HISTORIC AND DESIGN REVIEW COMMISSION

November 20, 2019

HDRC CASE NO: 2019-683
ADDRESS: 1418 W ROSEWOOD AVE
LEGAL DESCRIPTION: NCB 2763 BLK 68 LOT 8
ZONING: R-4, H
CITY COUNCIL DIST.: 1
DISTRICT: Keystone Park Historic District
APPLICANT: David Rodriguez/J D ROMI GROUP LLC
OWNER: David Rodriguez/J D ROMI GROUP LLC
TYPE OF WORK: Window replacement
APPLICATION RECEIVED: November 06, 2019
60-DAY REVIEW: January 05, 2020
CASE MANAGER: Huy Pham

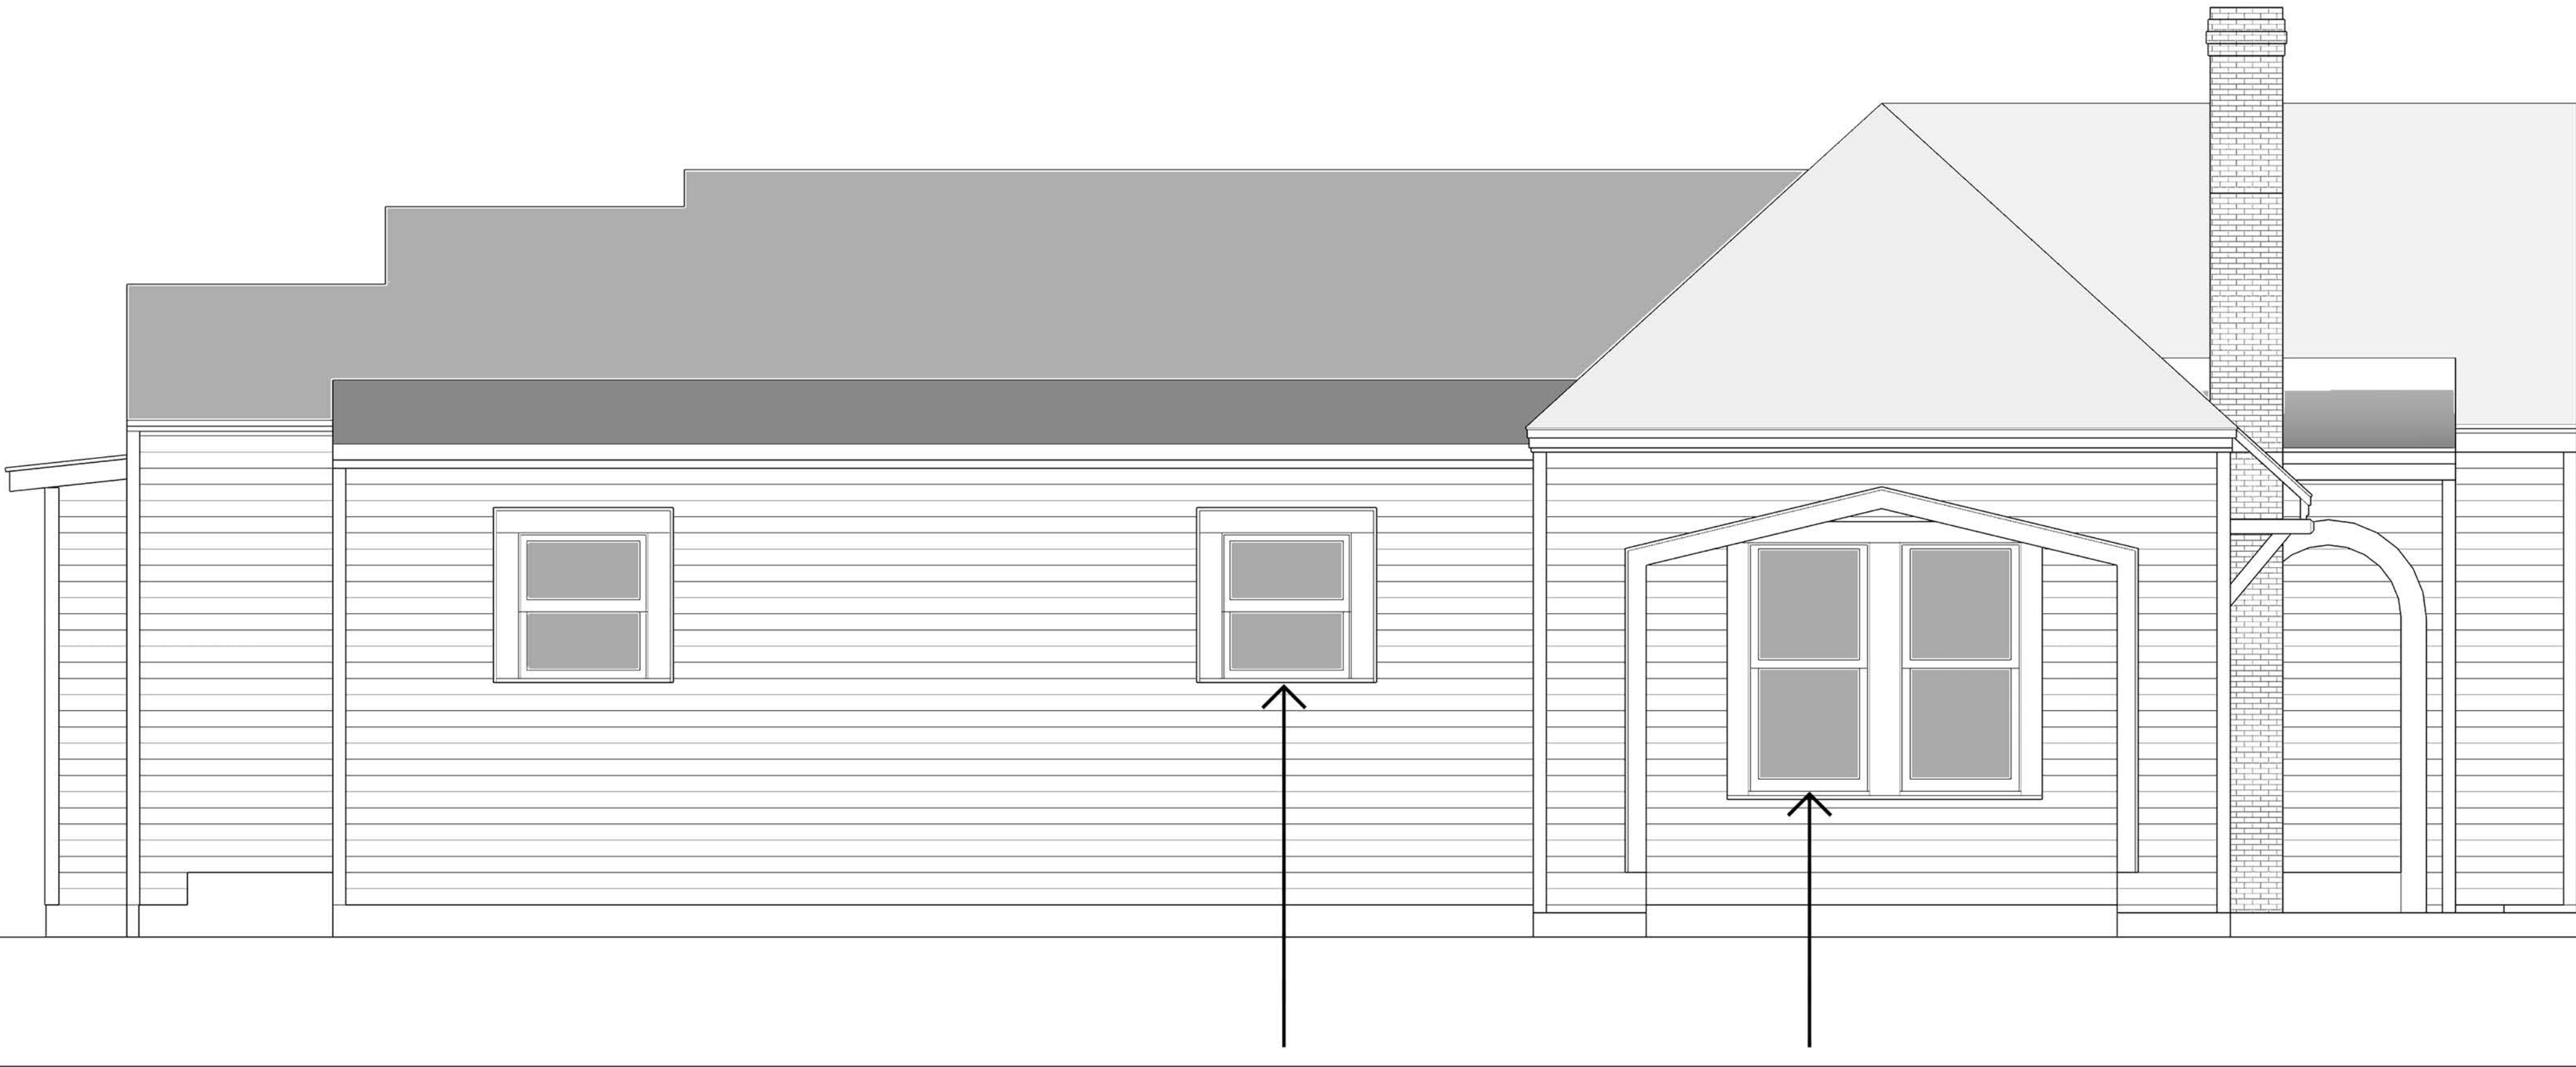
Existing gravel driveway has severe erosion. Driveway to be paved with concrete.

Exterior of house has had damaged original wood siding previously covered with vinyl siding.

The intent is to replace damaged vinyl siding with new vinyl siding and paint.

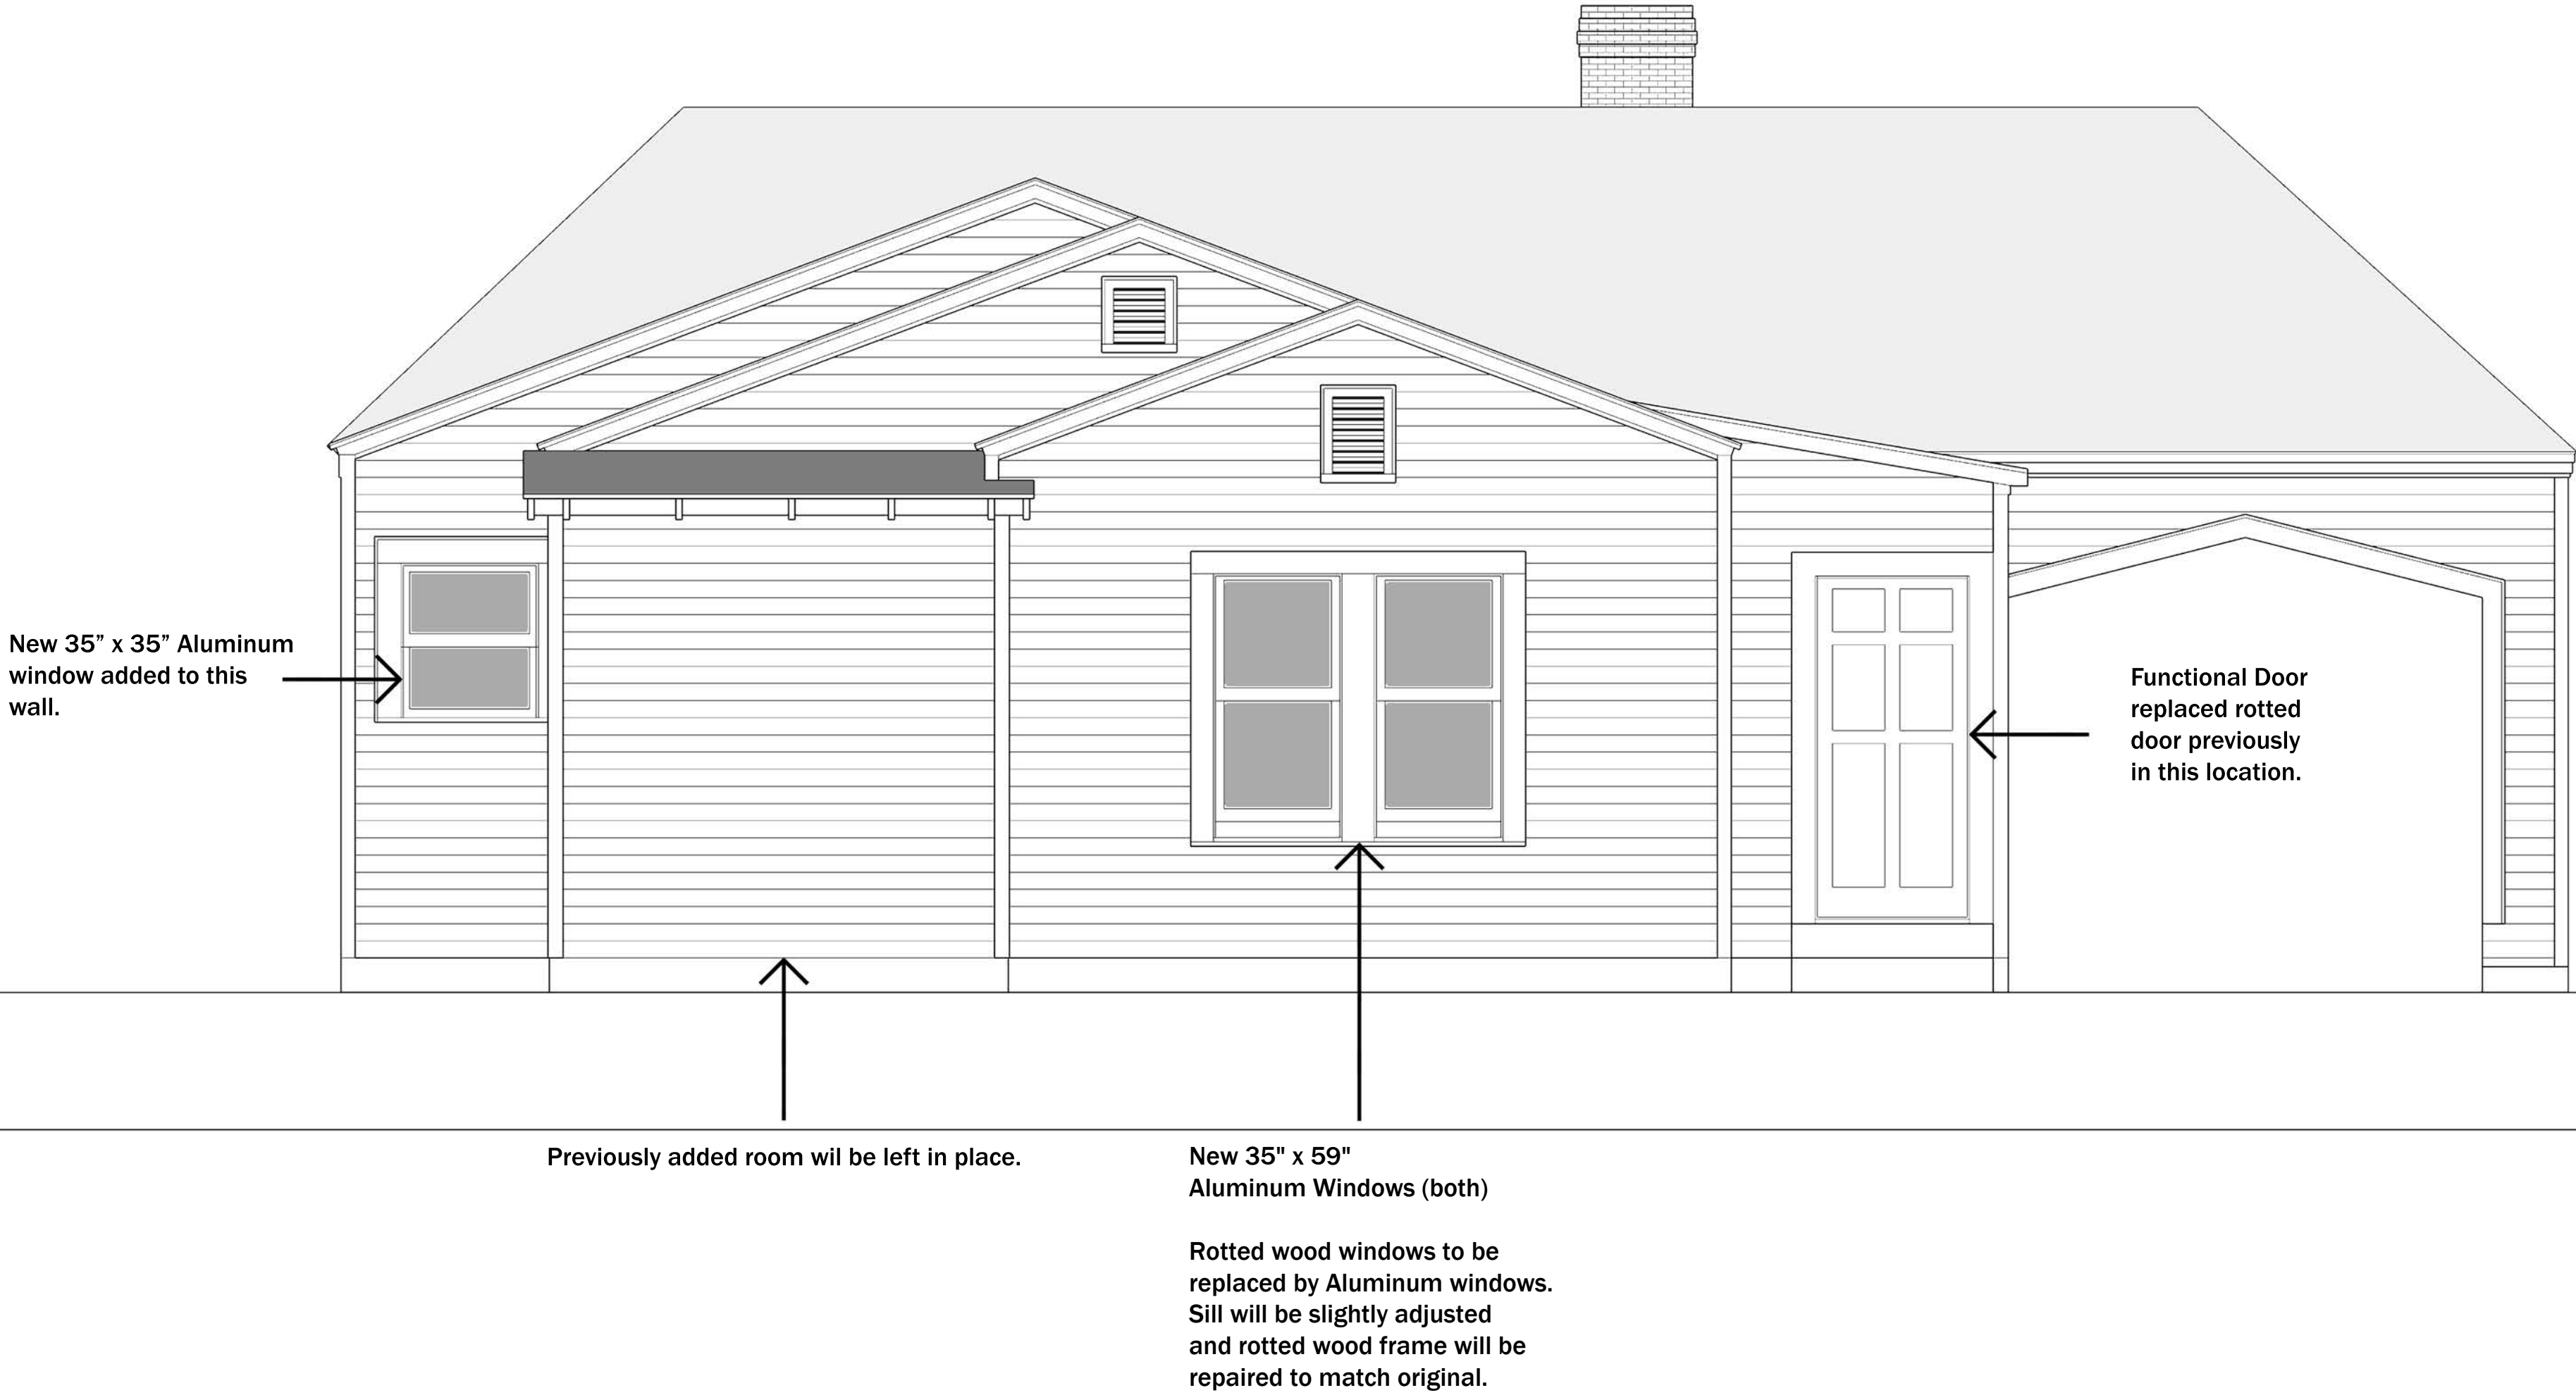
Existing front steps have shifted and become a hazard. The intent is to adjust the existing steps to be flush with front walkway.

Previously enclosed porch was severely rotted as were the added walls and doors that completed the enclosure.

Walls reconstructed.
Matching vinyl siding will be put on this wall to match the rest of the exterior.

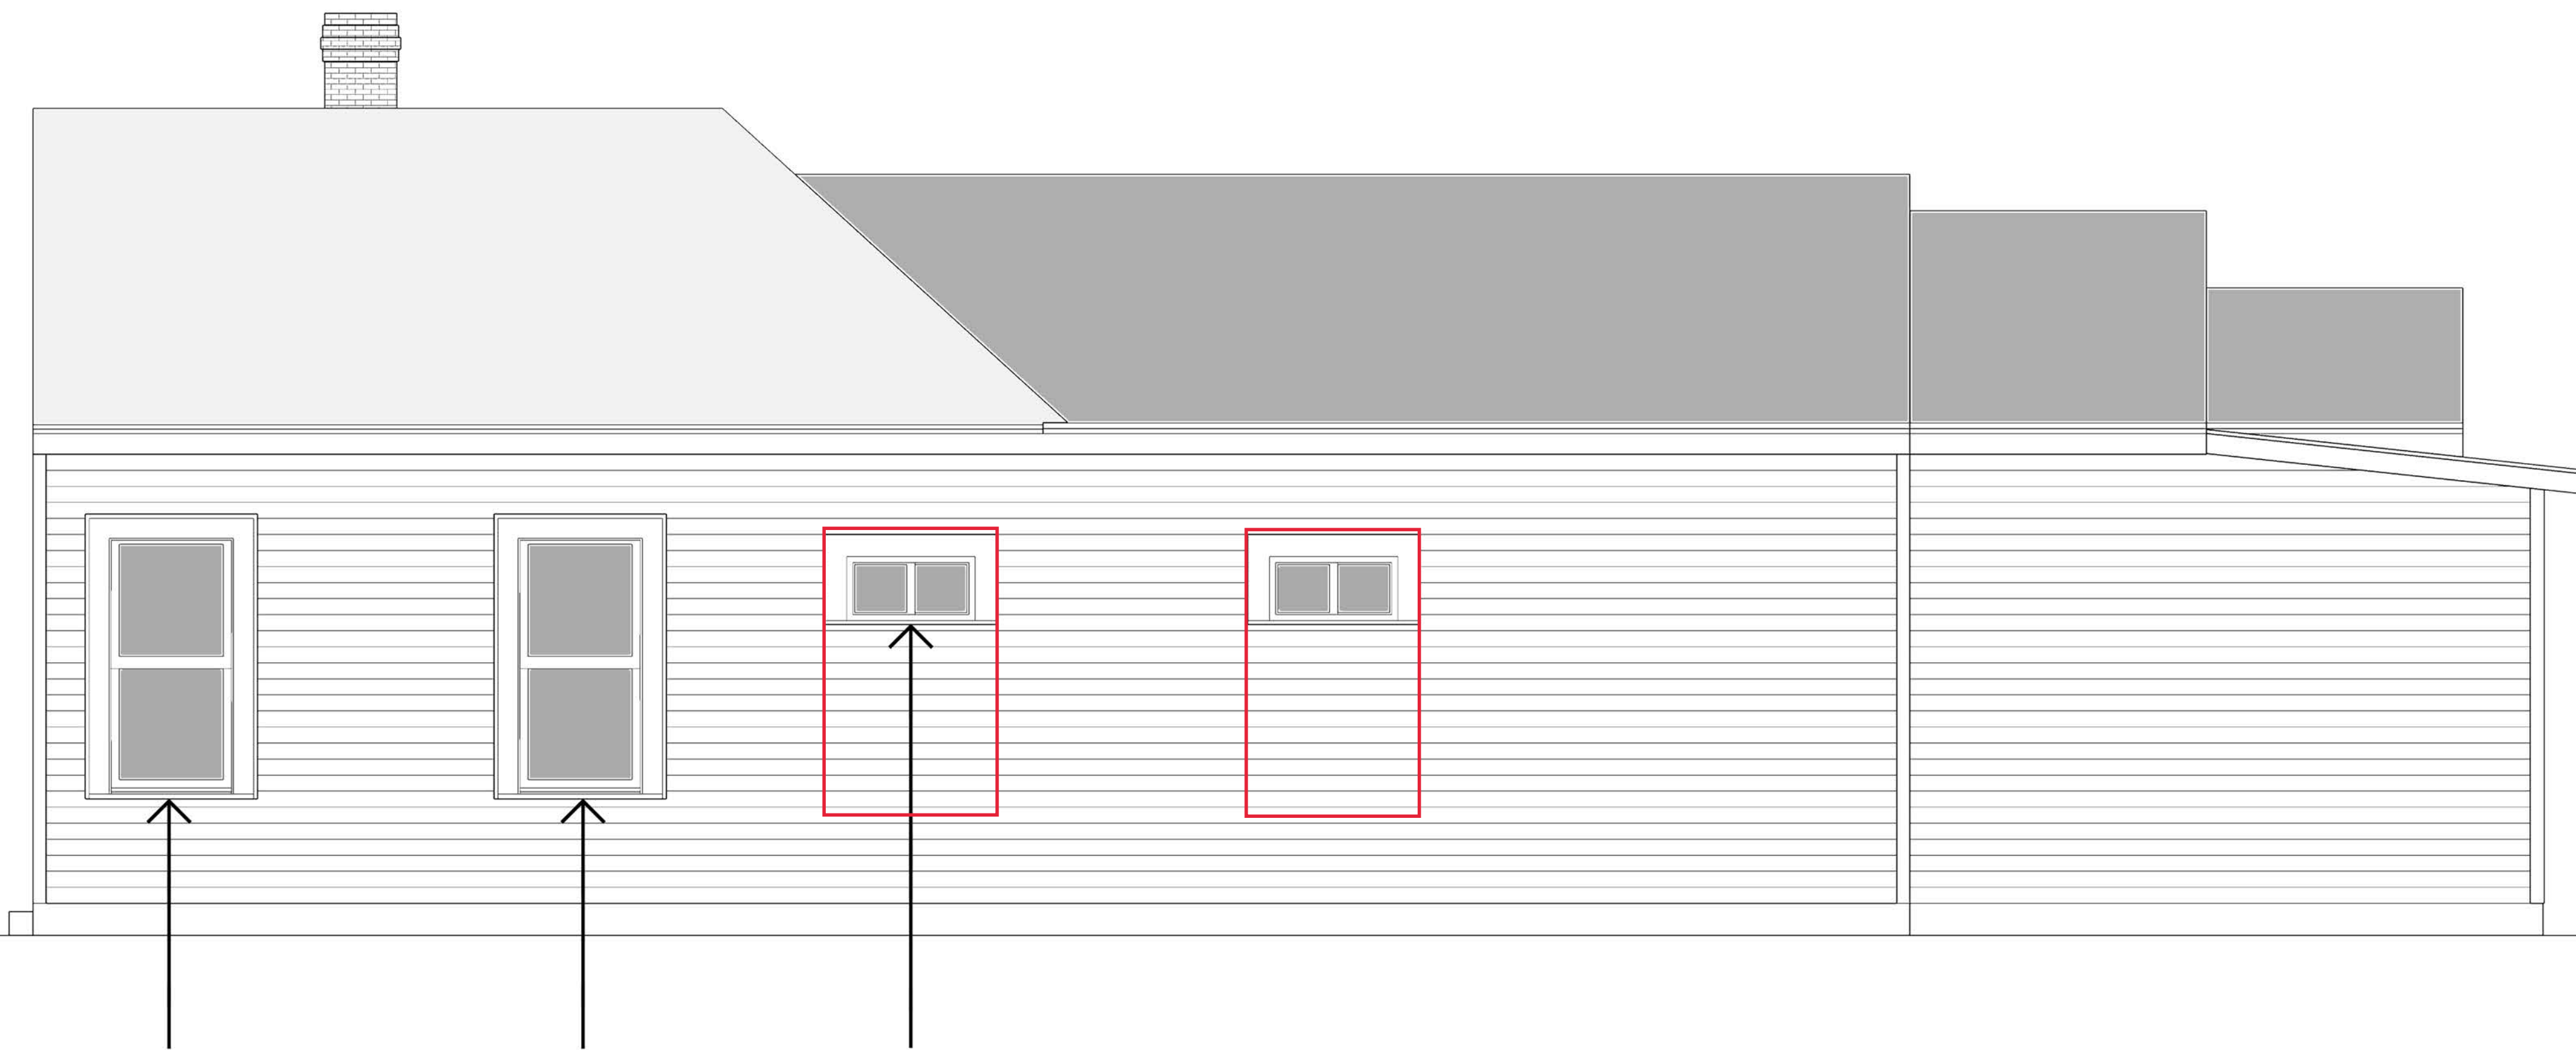
New 35" x 35" Aluminum Windows

Both installed on this wall to make the interior more functional

New 18" x 35" Aluminum Windows installed on this wall to correspond with interior (both).

The applicant has withdrawn the request to change these two window opening sizes.

The sizes will be restored with the request to replace with aluminum.
